# UNITED STATES PATENT AND TRADEMARK OFFICE

# Office Action Summary

10/539,148

KANFLOD ET AL.

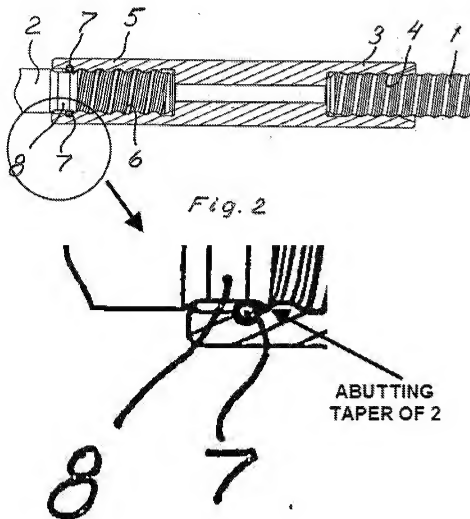
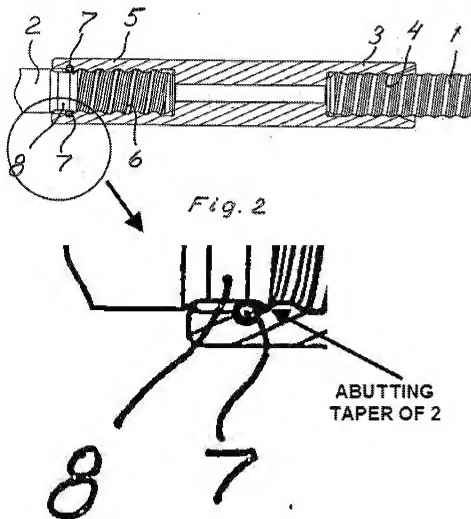
The drawings were received on 3/10/2011. These drawings are not acceptable since they contain new matter as shown below. Regarding figure 2, note that the space defined by elements (2, upper 10, and new matter line 100) is new matter. The originally filed figure 2 did not contain line 100, and thus the space defined thereby was originally occupied by a portion of element 3.

- The newly added recitation “as illustrated by Fig.2” (last paragraph of second page) which indicates that figure 2 shows “unloaded” is new matter. Note that figure 2 shows locking contact between lower pin (7) and the abutting taper of machine (2) such that it shows --loaded--. See applicant’s declaration filed 3/10/2011 which states (p.3, ll.3-8) that “loaded” is equivalent to “locked” while the term “unloaded” is equivalent to “unlocked”. Clearly pin (7) is as “locked” (loaded) as possible in figure 2. That is to say that there is no physical configuration of applicant's invention that is any more locked or loaded than that which is shown in figure 2, such that calling figure 2 “unloaded” amounts to new matter.

bolt (1) is connected to the coupling sleeve (3, 5). In fact even if figure 2 depicted locking device (7) to be unloaded (although it appears loaded) there is no structure to prevent the loading of locking device (7) to retain the rock drilling machine (2) connected to the coupling sleeve (3, 5) regardless of whether or not rock bolt (1) is connected or disconnected, since rock bolt (1) has no contact with either of locking device (7) or drilling machine (2) (even when the bolt is installed) and thus cannot prevent relative loading between device (7) and machine (2).

It is unclear how “said locking device is loaded to retain the rock drilling machine connected to the coupling sleeve only when said rock bolt is disconnected from said coupling sleeve...” (lines 9-11 of claim 1). Particularly, what structure would prevent loading of locking device (7) when one attempts to remove rock drilling machine (2) from sleeve (5, 3) while the rock bolt (1) remains connected to sleeve (5, 3)? Does applicant mean for the limitation as merely one possible intended use rather than a structurally limiting feature of the product? See applicant’s figure 2 above, which shows that there is no structure to prevent said locking device

(7) from being loaded against the abutting taper of said machine (2) to retain the rock drilling machine connected to the coupling regardless of whether said rock bolt (1) is disconnected or connected from said coupling sleeve (5, 3) since the rock bolt is not the sole source of all possible applied loads.

Note that applicant has argued that figure 2 shows pin (7) in a loaded position and figure 3 shows pin (7) in an unloaded position. However, both figures show pin (7) in identical positions (i.e., physically abutting the tapered portion of machine (2)). It is unclear how the claimed “unloaded” (claim 1) and “loaded” (claim 1) states structurally differ from one another.

Applicant argues that the drawings submitted 3/10/2011 do not contain new matter. This is not persuasive since figure 2 contains new matter as detailed elsewhere above.

Applicant argues that figure 2 shows pin (7) unloaded and figure 3 shows pin (7) loaded. This is not persuasive. Both figures show pin (7) in the same configuration (i.e., in direct

locking contact with an abutting taper of machine (2). How can the same structural configuration be considered both loaded and unloaded (i.e., locked and unlocked)? Is the loading a mere functional intended use rather than limiting structure?
